Staff Report – Planning & Zoning Item

Date: June 20, 2017
Case No.: P-17-07
Request: Replat
Applicant: Better Belton Foundation/
Belton Engineering

P-17-07 Hold a public hearing and consider a replat for Burnet South Addition, Phase I, a 0.424 acre tract of land, located on the east side of South Burnet Street, generally south of Avenue A and north of Avenue C.

RE: Project: Burnet South Addition Phase I

FINAL PLAT

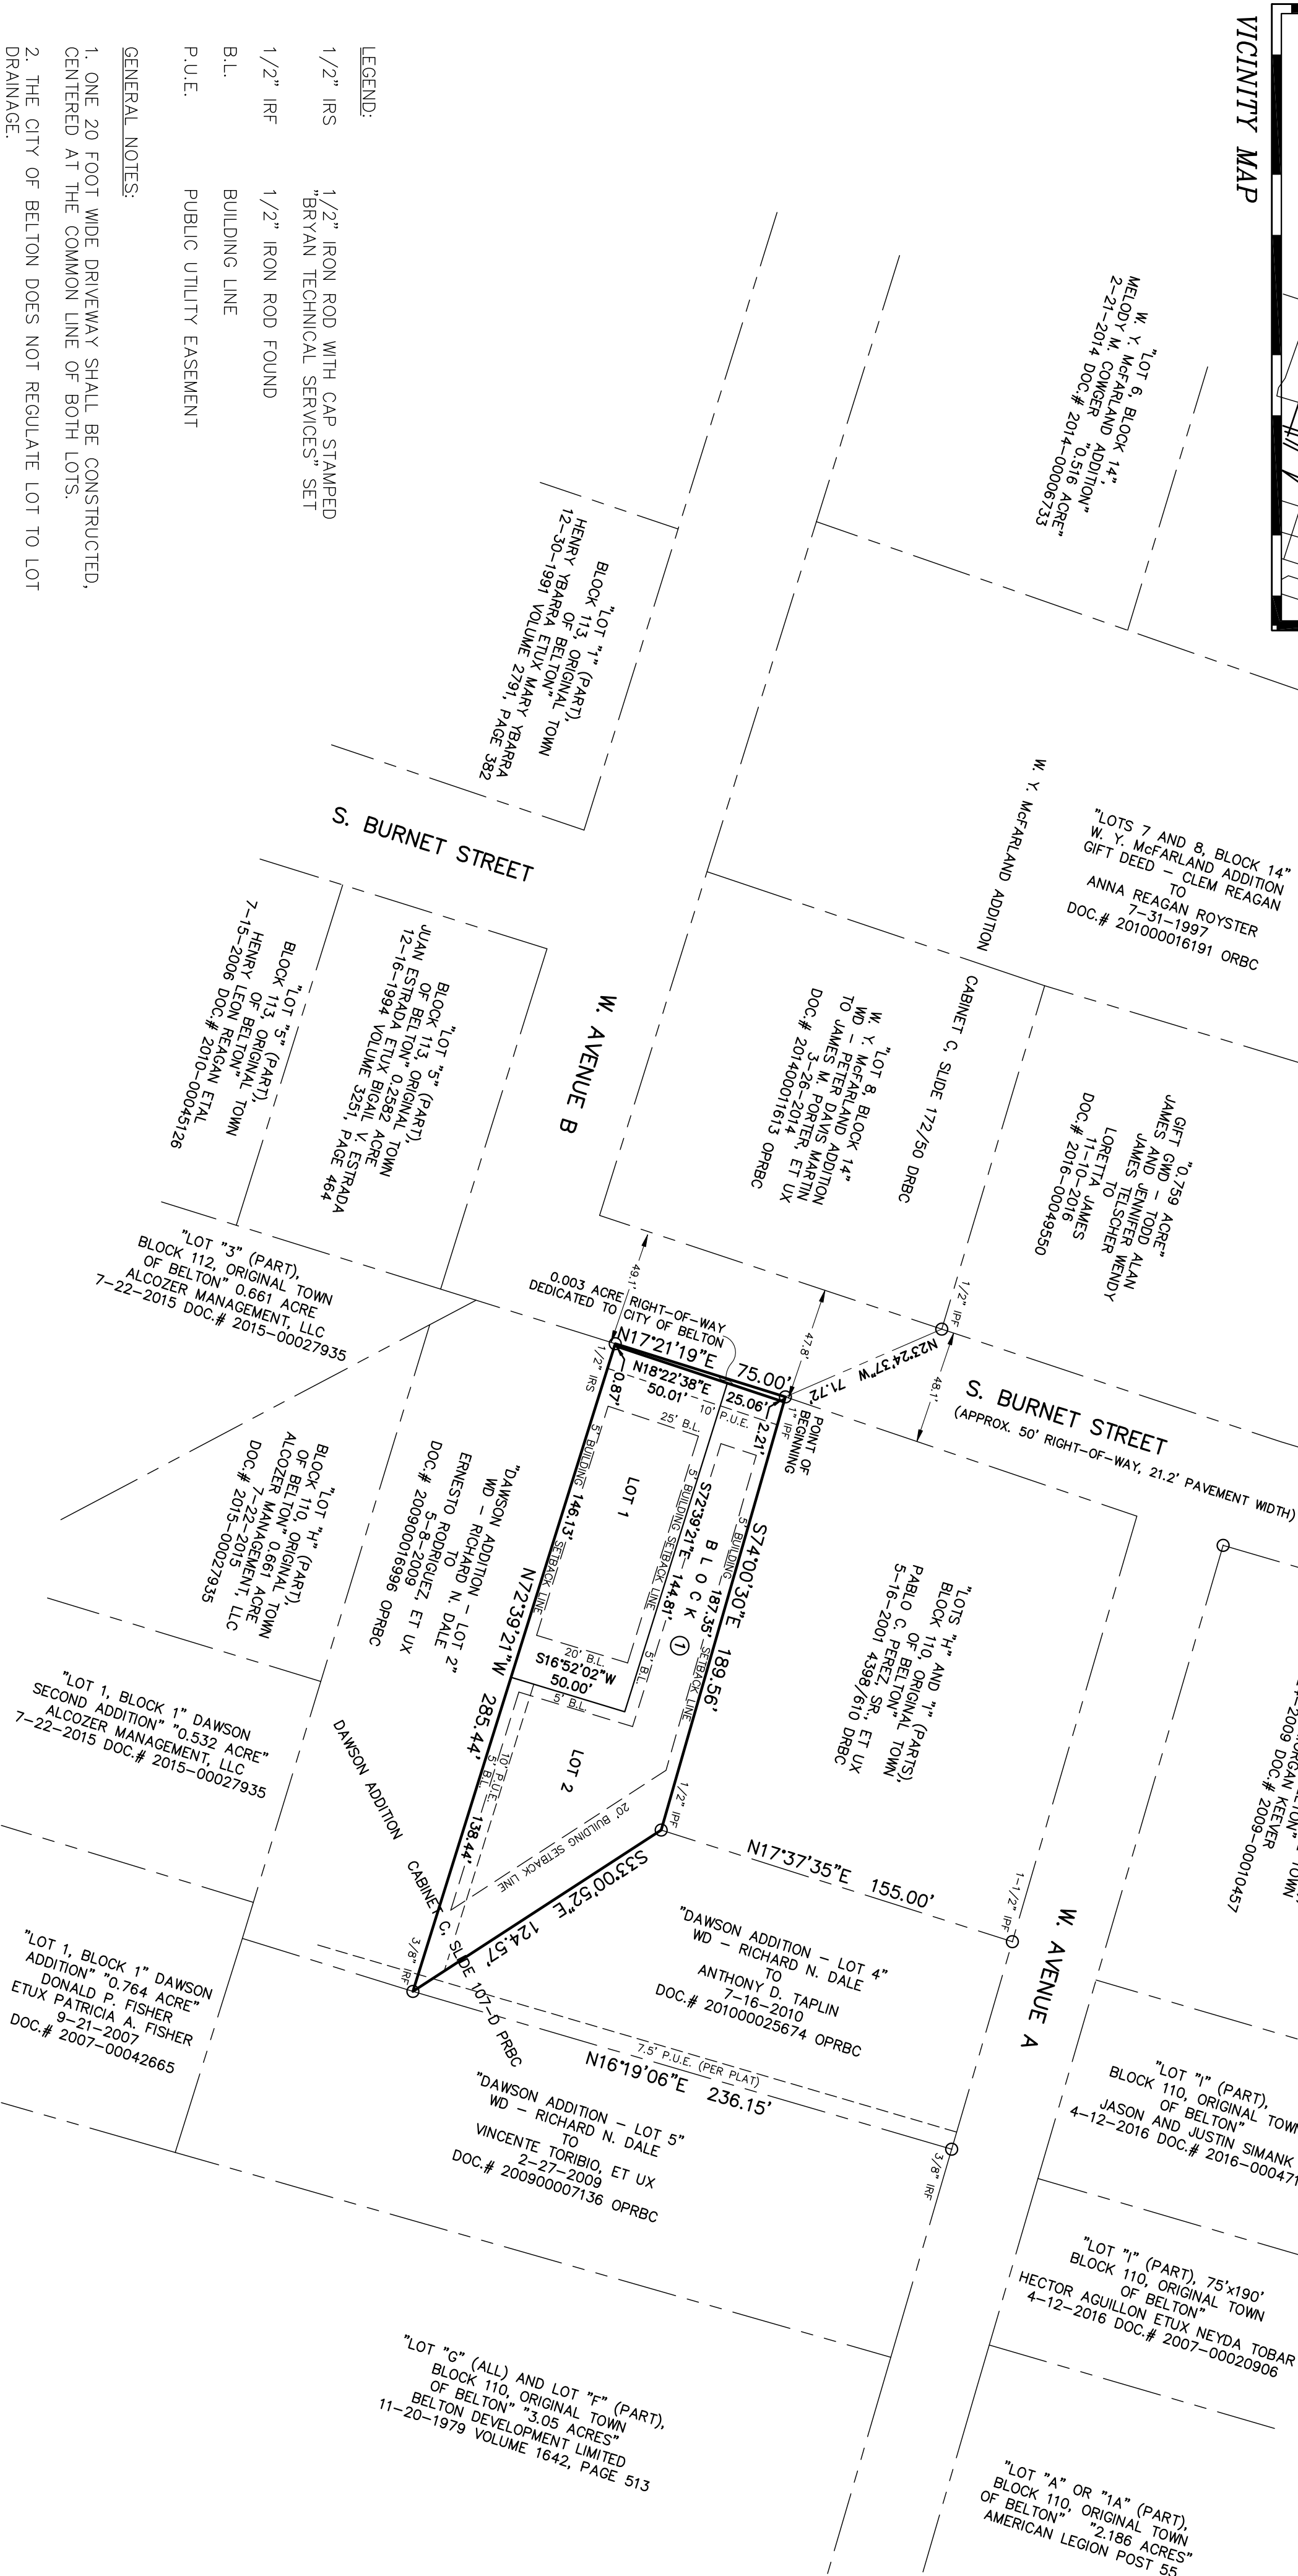
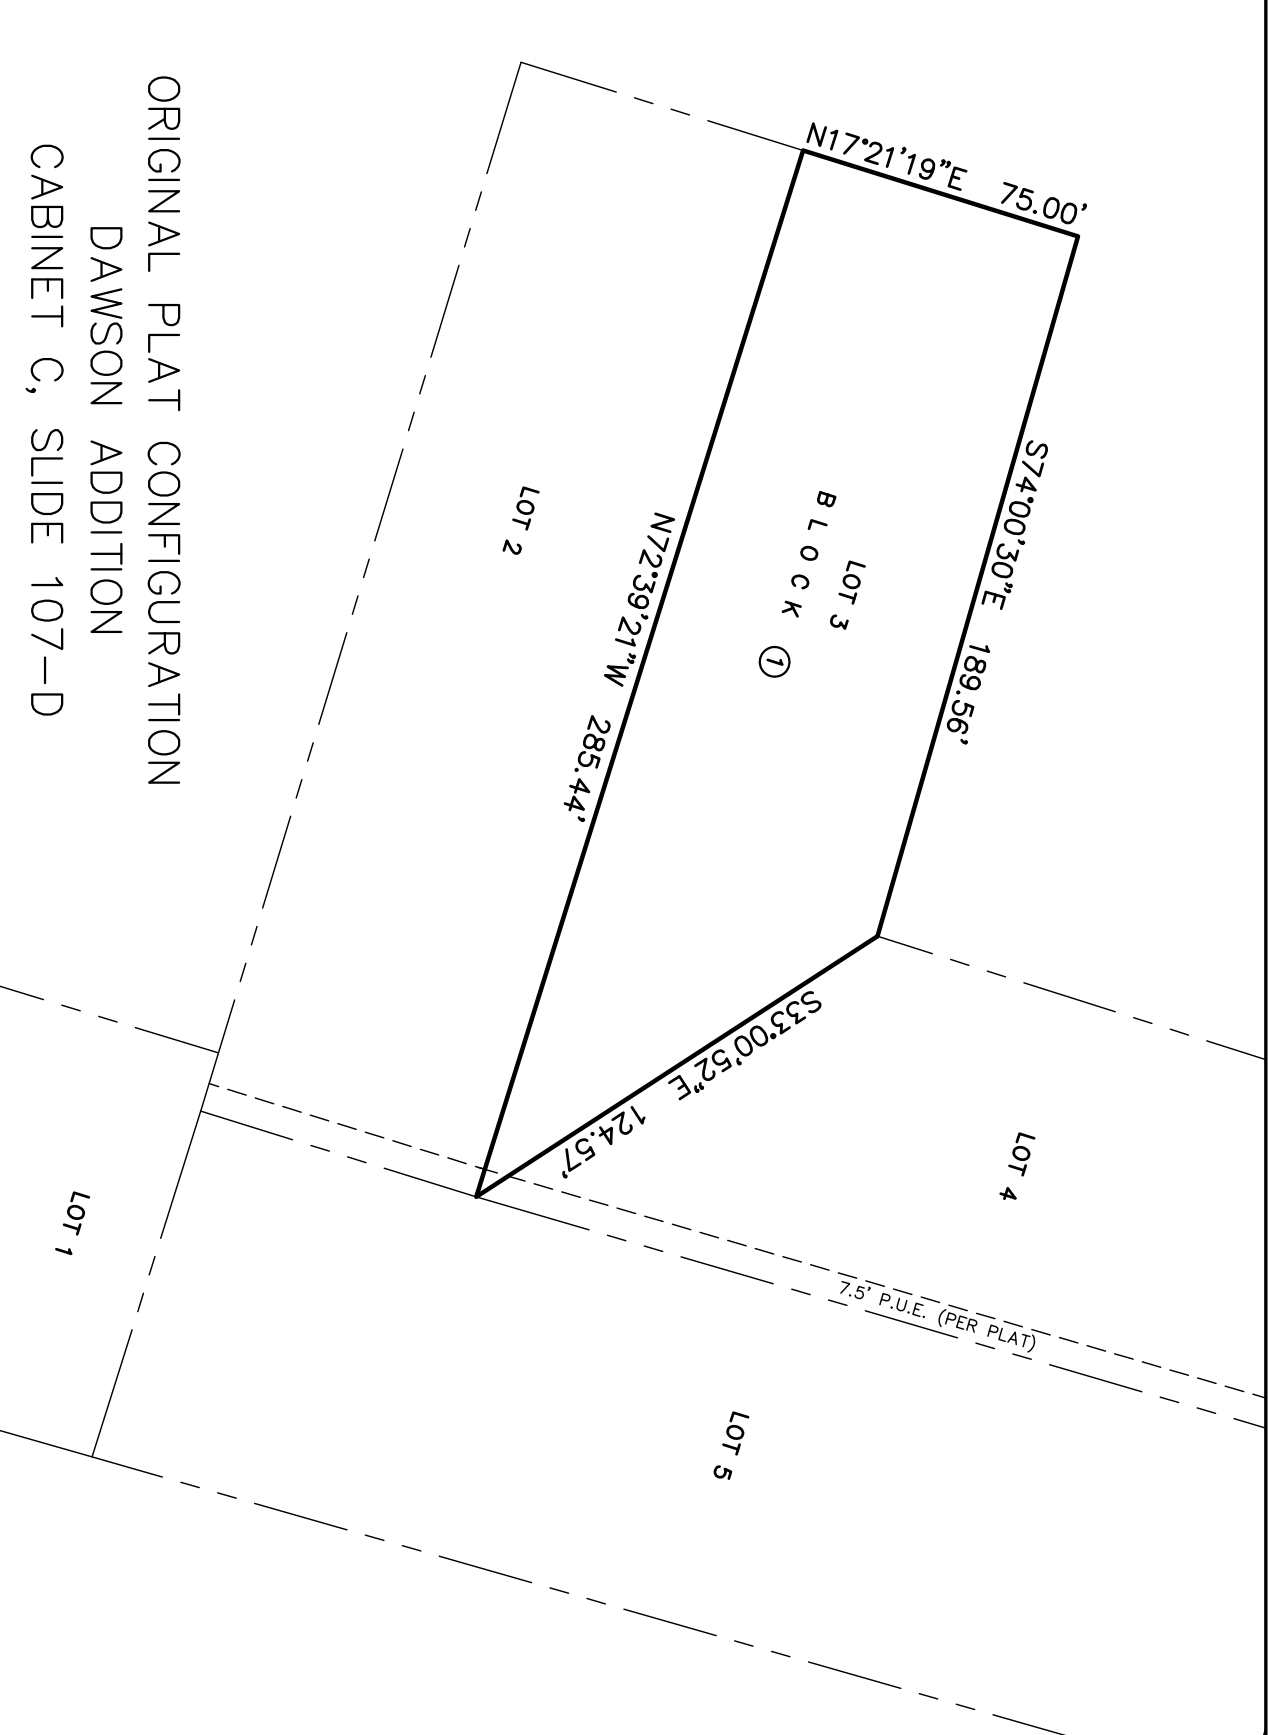
1. Please submit any applicable deed restrictions.
 - **NO RESTRICTIONS ARE TO BE RECORDED FOR THIS PLAT**
2. Provide written certification from all utility providers and Clearwater UWC.

- **All providers have been emailed a copy of the proposed plat**
3. Please submit a tree survey of all protected trees 20 inches and larger for staff review. Please state the trees proposed to remain and the trees proposed for removal.

4. **All existing trees are to remain.** The house from 110 East 11th Avenue was moved onto this lot before it was proposed to be replatted into 2 lots. Why is the house located so far back into the proposed lot? Please contact me to discuss.

5. An electrical and plumbing application was submitted in October 2016 and we sent comments on October 18, 2016 that have not been addressed. What is the status of this project?

6. **We will re-apply for this elec. and plumbing for the proposed two houses.**
7. What is the plan for driveways for these properties?
 - **See attached sketch. One 21' wide drive, with a 1' space shall be constructed to remove any impact on existing roadway.**

8. According to the Subdivision Ordinance, this property is proposing an additional single family home which requires a park dedication of 0.01 acres or a \$200 fee-in-lieu of park dedication. Please submit a \$200 fee to be utilized in Harris Community Park.

- The developer shall submit a \$200 fee in lieu of park dedication.
- 9. Please identify the ROW width adjacent to the southern and northern portion of this property. If the ROW is less than 50', recommend a dedication to achieve a ROW width of 50'.
 - The existing right-of-way is not less than 50'.
- 10. According to the Subdivision Ordinance, the developer is required to contribute half the total cost of paving and installing curb and gutter for the portion of South Burnet Street adjacent to this subdivision. Please address the perimeter street improvement requirements.
 - The improvements shall exceed the lots value. Therefore we request exemption of this request.

- Drainage will need to be addressed with the building permit for Lot 2. If additional impervious area is proposed, post-development flows must not exceed pre-development.

- Please provide scalable drawings.
 - "SCALABLE" sheet copies are being provided with this response
- Has ONCOR Electric Delivery been involved in determining how power will serve the lots?

- **At the time the house was placed it was unclear whether or not the City would allow for a subdivision of this lot, therefore it was placed in a similar fashion as the existing building to the south. (adjacent lot)**

- There are no new streets proposed with this development. The impervious area proposed, shall be only 14% of the existing lot. Additionally, a minimum time of concentration (15 minutes) as dictated in the drainage criteria for the City of Belton shall result in the same I (intensity), the area(s) are not affected by this development, and the C factor shall remain the same based on adopted values for residential land use single-family lots < 1.0 acres, as listed in Exhibit 5.4, Design Parameters, Section 5, City of Belton Drainage Criteria Manual.

- All utility providers, (including ONCOR), have been sent a copy of this plat for their review and comment.
- If the sewer service line for either lot runs across the other lot, a private easement will be required.

The developer requests that a dual share sewer service be allowed for this subdivision. However, if the City utility director does not allow said dual service, the developer will install separate services which shall not cross into each others property.

FINAL PLAT

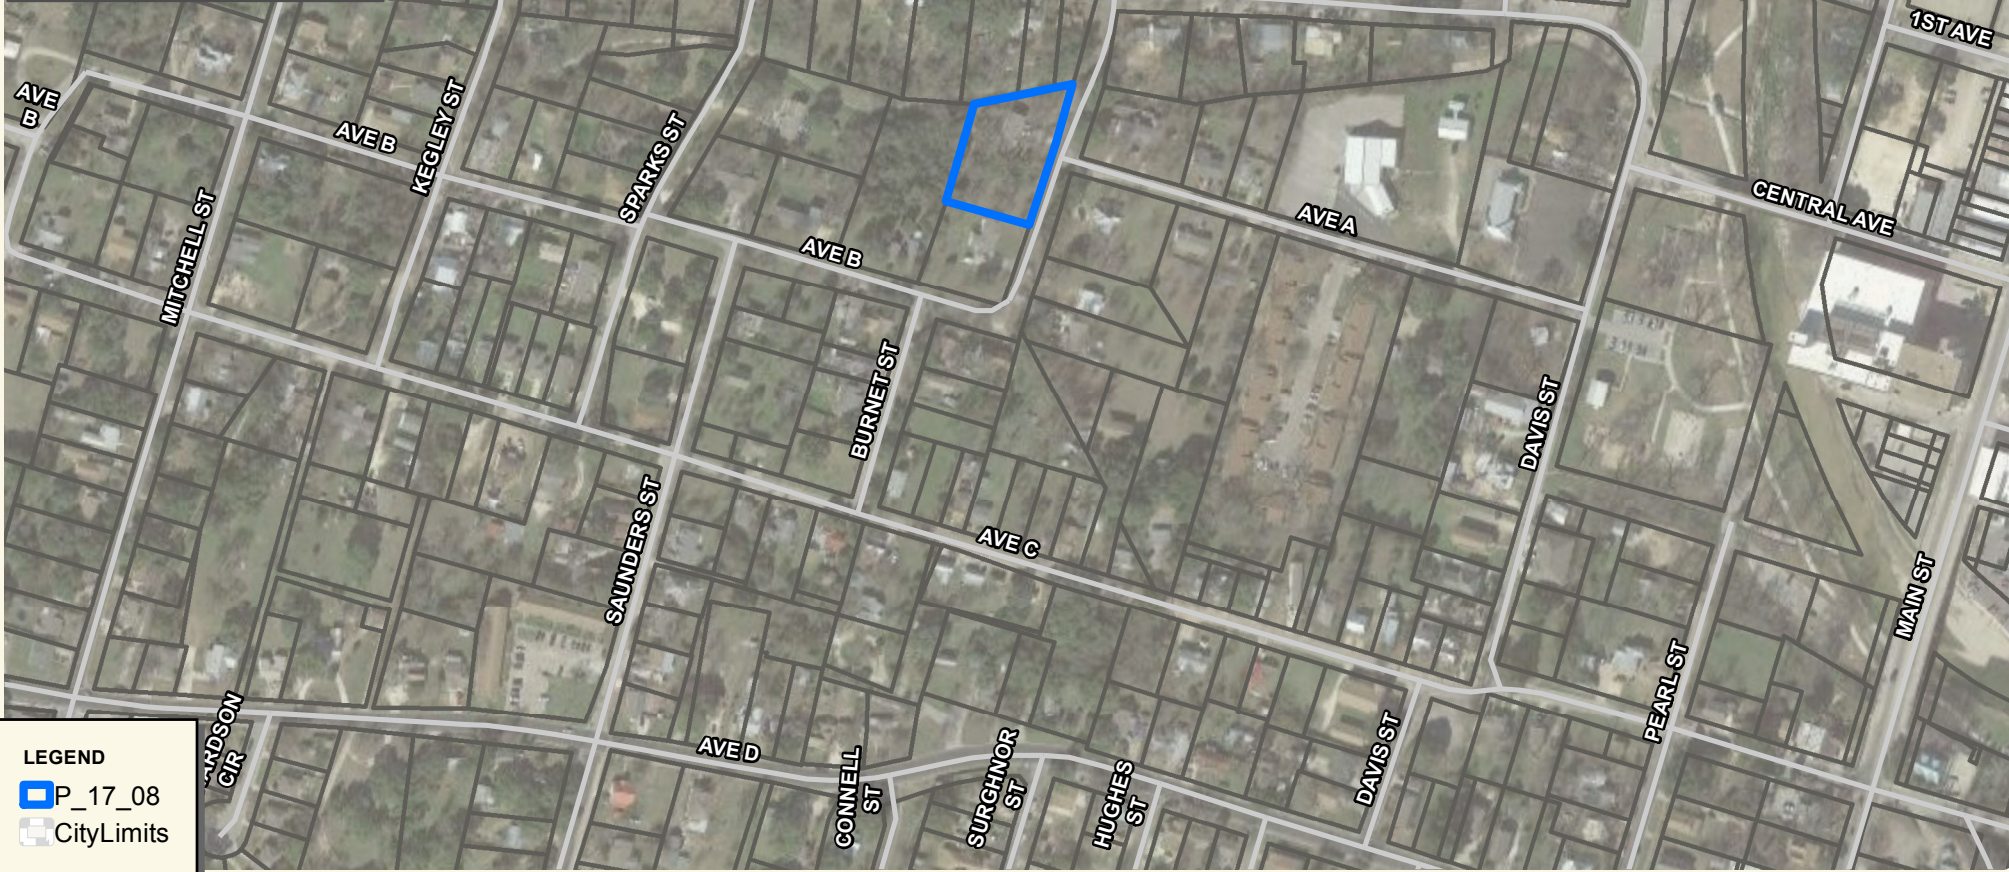
1. This plat is not ready for P&ZC and Council consideration and will not move forward to the May meetings.
 - Duly noted.
2. This property is zoned Single Family-2 with a CR Overlay. The lots proposed do not conform to the SF-2 requirements. In the CR Overlay District, the requirements of the base zoning district (SF-2) shall apply. The SF-2 District requires a minimum lot width of 60' and a minimum lot area of 7,500 square feet. This plat may not move forward as proposed, since it does not comply with the minimum lot area regulations.

4. Please show the original lot configuration on the plat.
 - Showed inset of original lot configuration.
5. Is the mobile home proposed to be moved or will it remain?

8. Please submit a tree survey of all protected trees 20 inches and larger for staff review. Please also state on the tree survey or a separate sheet the trees proposed to remain and the trees proposed for removal.

- Developer shall submit the park fee.
10. Please identify the ROW width adjacent to the northern portion of this property. There appears to be less than 50' of ROW (48.1' at southern end; 49' at middle; please identify width adjacent to northern portion). Recommend a dedication to achieve a ROW width of 50'.

- The requested right-of-way dedication to achieve a 50' foot total width has been added to the plat.
11. According to the Subdivision Ordinance, the developer is required to contribute half the total cost of paving and installing curb and gutter for the portion of South Burnet Street adjacent to this subdivision. Please address the perimeter street improvement requirements.

1. The 40' drainage easement will not be abandoned. Eliminating the easement will limit the possibility for positive overflow in large storm events, and the Burnet Plat is on the low side of the overbank. Also, there are no channel calculations or HEC-RAS analysis provided that would define the 1% annual chance floodplain. This is required, at a minimum, to determine the extents of the floodplain to evaluate whether or not the drainage easement could even be reduced.

- We shall adjust the C values to match city of Killeen drainage criteria manual as proposed and agreed to by the City of Belton engineer.
3. The elevations shown in Section A of the channel are incorrect.

- We have corrected the "typo" error of the elevations.
4. The n-value used for the existing RCP culvert calculations is 0.012. However, an n-value of 0.013 is typically used for RCP. Although the result may not change, please

- The n-value requested has been used in the RCP culvert calculations.
5. Based on the plat, it appears that the existing residential structure encroaches into the drainage easement. Please consult the Floodplain Administrator to determine if an elevation certificate is needed. A waiver may also need to be requested by the property owner to allow the structure to remain in its current location (encroaching on the drainage easement).

8. The sewer lines are shallow in this area. Once the final lot layout is determined, the exact location of sewer will need to be identified on the utility plan sheet. A minimum 6" sewer line extension will be required to serve this development due to the shallow gravity sewer lines on Burnet. This sewer line extension will require crossing the street with steel reinforced concrete cap.

1. Will the existing structure be removed?
 - The existing structure shall be re-located onto one of these proposed lots.
2. Existing structure appears to be crossing lot lines and is encroaching into the 40' drainage easement.
 - The existing structure shall be re-located onto one of these proposed lots.
3. The plat does not appear to be in the flood hazard area.
 - Agreed.
4. This property is zoned SF-2 which requires a 25' front, 20' rear and 6' side yard building setback lines. Lot 4 on the proposed plat only shows a 15' front yard building setback. Please revise to show all SF-2 setbacks on the proposed lots.
 - All lots on plat have been updated to show building setbacks for SF-2 zoning.
5. Lot 4 does not appear to have adequate buildable area due to required building setbacks and the 40' drainage easement.

- The lots have been re-configured to total 3. These proposed lots shall conform to SF-2.
3. Please include all building setback lines on the plat.
 - All setbacks have been added to the plat.

- It shall be adjusted to fit on of these new lots.
6. Please submit any applicable deed restrictions (existing and proposed).
 - There are no existing deed restrictions on record for these lots.

- An on-site review of this lot, reveals that no protected trees 20 inches and larger exist on subject lot.
9. According to the Subdivision Ordinance, this property is proposing three additional single family homes which requires a park dedication of 0.03 acres or a \$600 fee-in-lieu of park dedication. Please submit a \$600 fee to be utilized in Harris Community Park.

- The improvements cost shall exceed the development value. Therefore we request exemption of this request.

- The developer shall not abandon or reduce width of existing drainage easement, No HEC-RAS analysis is needed.
2. Please adjust the C-values by storm event.

- No need for HEC-RAS extensive analysis.
 7. What are the proposed water and sewer connections for each lot?
 - We have updated the utility plan to show proposed services.

- The lots have been re-configured to satisfy this comment.
